Second Submissions Report

Infill Affordable Housing

2 - 16 Pockley Avenue, Roseville

SSD-77825469

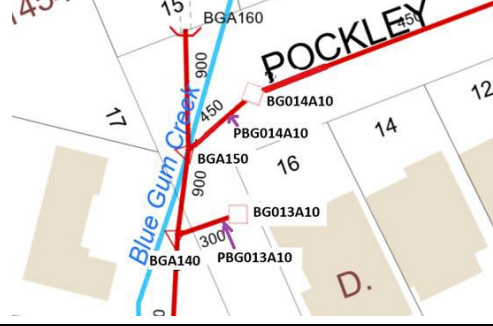
Gross Floor Area		
7	Original concerns remain.	The exhibited Combined Submission and Amendment Report included clarifications on the application of the additional bonuses for FSR under the infill affordable housing provisions of the Housing SEPP for the amended scheme.

Item no.	Issue/ Comment	Proponent Response
		• Detailed information has been provided in relation to the allocation of GFA between market residential GFA, affordable housing (in-perpetuity) GFA and affordable housing (min. 15 years under infill affordable provisions) GFA. • Refer to the revised GFA Schedule and GFA Diagrams provided in architectural documentation.
Building setbacks		
8	<i>Insufficient setbacks</i> The proposed setbacks remain a key contention for Council. The result of the proposed setback deficiencies will be a building that irrevocably changes the character of Lindfield by destroying the garden setting of the neighbourhood. Considering the additional height afforded under the repealed TOD provisions, full compliance with the setbacks outlined in Council’s original submission would reduce the overbearing impact of the development. Likewise, insufficient justification has been provided to support the encroachment of balconies at ground level. Lastly, to support canopy growth for tall trees, it is recommended that the setbacks be increased. Notwithstanding the increased basement setbacks, the deep soil zones are still incapable of supporting canopy trees to maturity due to restricted airspace for copy expansion.	• The amendments made in response to the first RTS for the project included increasing basement setbacks to the east and west boundaries. • Woods Bagot has advised that the basement setback from the eastern boundary along Larkin Street has been maximised to support an increased setback from the western which to allows for a more generous COS as well as deep soil zone to this frontage that also provides a greater buffer to lower density residential areas to the south. • It is noted that the proposal has made provision for 706 sqm (10.8%) of deep soil which is beyond the 7% requirements of the ADG. Further, the 1,540sqm of tree canopy proposed (including retained), representing 23.5% of site area, is a notable improvement to the existing tree canopy context of the site at 1,044 sqm (15.9%). • The following consideration for setbacks demonstrates a reasonable response for a constrained site and that alternative solutions were investigated: – Woods Bagot advised that the decision to move the pavilions towards Larkin Street was determined carefully to provide reasonable separations between each pavilion. This was acknowledged and supported by the SDRP 01 as “rigorous testing of massing(s)” and the resulting “siting of the buildings, which is a logical response to a steeply sloping site”. – The eastern setback is also limited due to functional efficiencies of the basement layout which are already at its limit with respect to aisle widths and carpark depths. Should this arrangement change, it risks deeper excavation to attain the required number of car spaces, as well as possible further encroachment to the western COS and deep soil zone. – The proposal provides an urban and landscape design response to maintain as much space on the western boundary to enhance the proposal’s engagement with the biodiversity zone in the area and minimise impacts to lower density areas to the south. – Due to the steep slope of the site, the alternatives of moving the buildings east or west would not materially impact the vertical depth of the excavation, as the Ground Level of the lowest pavilion (Pavilion C) would
